PHOTOGRAPHS

PHOTOGRAPH #3

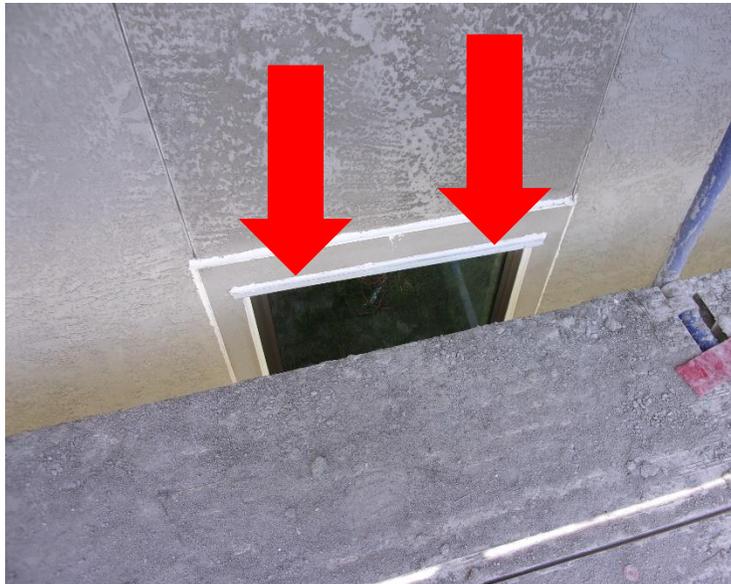
Interior window installation inspection confirms flashings and sealants in accordance with AAMA and manufacturer installation guidelines.

PHOTOGRAPH #7

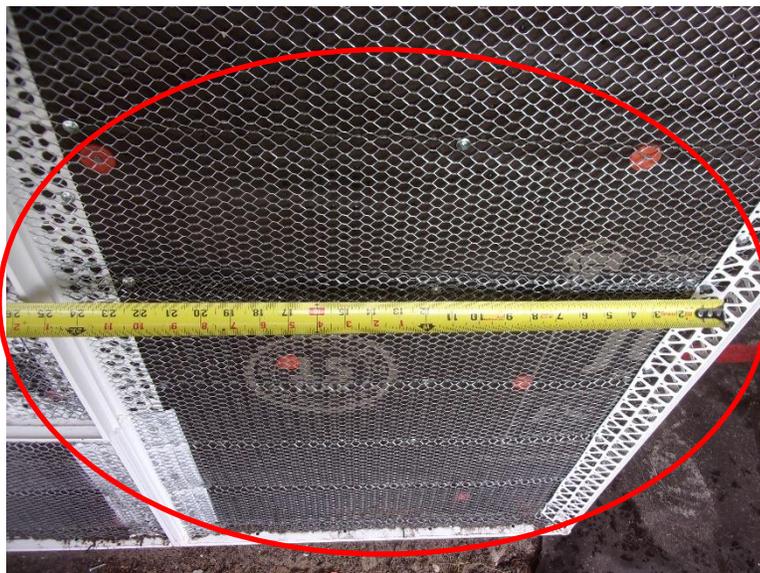
Stucco sub-contractor applying scratch coat of stucco.

PHOTOGRAPH #8

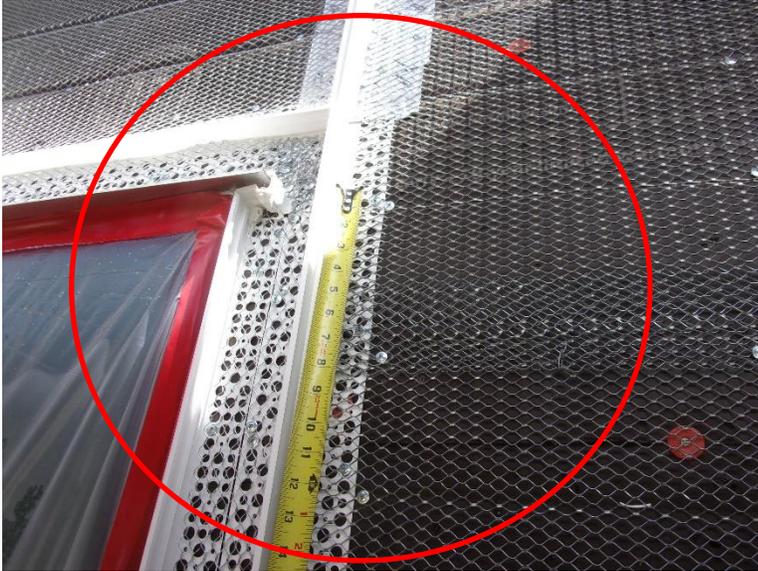
Lath and stucco accessories checked for correct fasteners, tie wires and lapping compliance.

PHOTOGRAPH #13

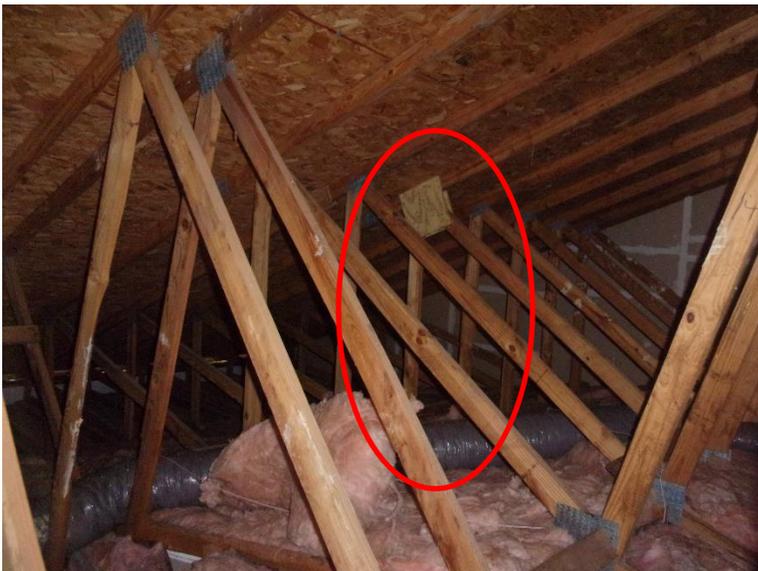
Simpson Strong-Tie strapping and termite treatment has been provided.
